Regulation No. 1117
**(UNIFORM PROVISIONS CONCERNING THE APPROVAL OF TYRES WITH
REGARD TO ROLLING SOUND EMISSIONS AND TO ADHESION ON WET
SURFACES
AND TO ROLLING RESISTANCE)**

Proposal for draft amendments to Regulation No. 117- Rev. 1

Submitted by the expert from the European Tyre and Rim Technical Organisation

Example 1

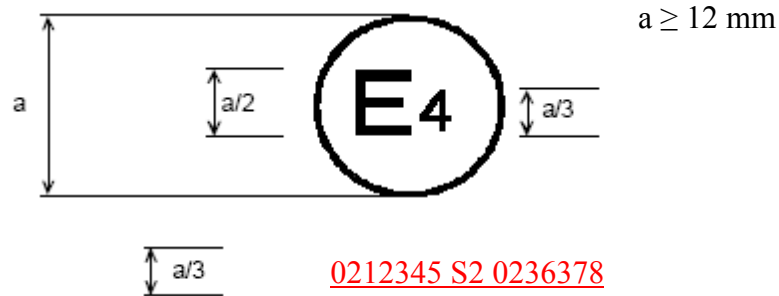
The above approval mark shows that the tyre concerned has been approved in the Netherlands (E4) pursuant to Regulation No.

~~The above approval mark shows that the tyre concerned has been approved in the Netherlands (E4) pursuant to Regulation No. 117 (marked by SS2 (rolling sound at stage 2)), under approval number 011234 0212345 and Regulation No. 30, under approval number 023637.0236378. The first two digits of the approval number (0102) indicate that the approval was granted according to the 01_02 series of amendments, ~~but~~ and Regulation No. 30 included the 02 series of amendments.~~

Example 2

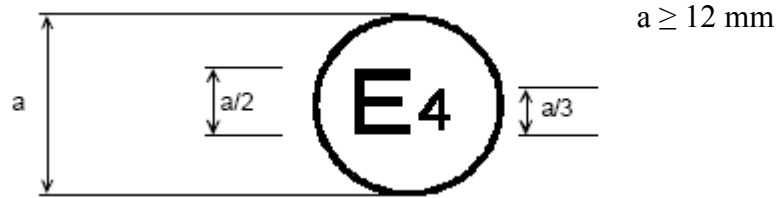
$\frac{a}{3}$ 011234 S or SW 0236370212345 S2WR2 0236378
 or
0212345 S2WR2
0236378

The above approval mark shows that the tyre concerned has been approved in the Netherlands (E4) pursuant to Regulation No. 117 (marked by ~~S-S2WR2(rolling sound) or SW (rolling sound and at stage 2 wet adhesion and rolling resistance at stage 2)~~), under approval number 011234 0212345 and Regulation No. 30 under approval number 023637-0236378. The first two digits of the approval number (0102) indicate that the approval was granted according to the 0102 series of amendments, ~~but and~~ Regulation No. 30 included the 02 series of amendments.

Example 3

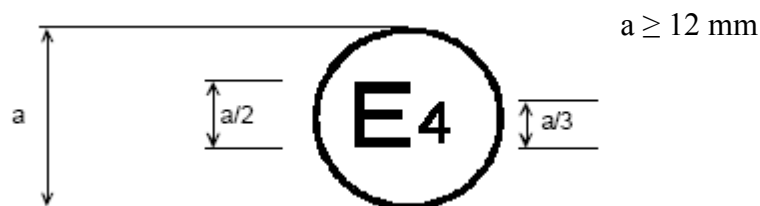
$\frac{a}{3}$ 011234 S-0054320212345 S2 0054321
 or
0212345 S2
0054321

The above approval mark shows that the tyre concerned has been approved in the Netherlands (E4) pursuant to Regulation No. 117 and the 0102 series of amendments under approval number 011234 0212345 (marked by S-only S2), and Regulation No. 54. This indicates that the approval is for rolling sound (S) only, as Regulation No. 54 approved tyres at present cannot be approved for wet adhesion stage 2 (S2). The first two digits of the Regulation No.

117 approval number (~~01~~02) in conjunction with "SS2" indicate that the first approval was granted in accordance with Regulation No. 117 which included the ~~01~~02 series of amendments. The first two digits of Regulation No. 54 (00) indicates that this Regulation was in its original form.

Example 2

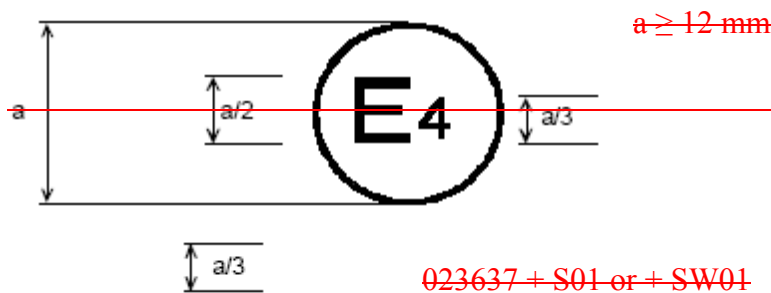
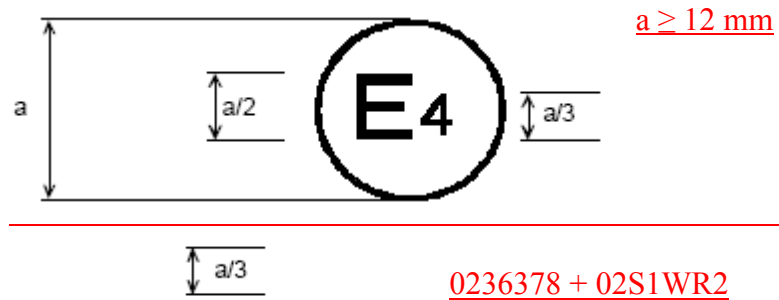
~~The above approval mark shows that the tyre concerned has been initially approved in the Netherlands (E4) pursuant to Regulation No. 30 and the 02 series of amendments under approval number 023637. This indicates that the approval 0236378. It is for also marked by + 02S1 (rolling sound) or S (rolling sound) and W (wet adhesion). The S or SW followed by (01) at stage 1) which indicates that it has had its approval is extended under Regulation No. 117 which included the 01 (02 series of amendments). The first two digits of the approval number (02) indicate that the approval was granted according to Regulation No. 30 which included the (02 series of amendments). The addition (+) sign indicates that the first approval was granted in accordance with Regulation No. 30 and has been extended to include the approval(s) granted according to Regulation No. 117 (02 series of amendments) for rolling sound at stage 1.~~

The above approval mark shows that the tyre concerned has been initially approved in the Netherlands (E4) pursuant to Regulation No. 30 and the 02 series of amendments under approval number 0236378. This indicates that the approval is for S1 (rolling sound at stage 1) W (wet adhesion) and R2 (rolling resistance at stage 2). The S1WR2 preceded by (02) indicates that it has had its approval extended under Regulation No. 117 which included the 02 series of amendments. The first two digits of the approval number (02) indicate that the approval was granted according to Regulation No. 30 (02 series of amendments). The addition (+) sign indicates that the first approval was granted in accordance with Regulation No. 30 and has been extended to include Regulation No. 117 approval(s) (02 series of amendments).
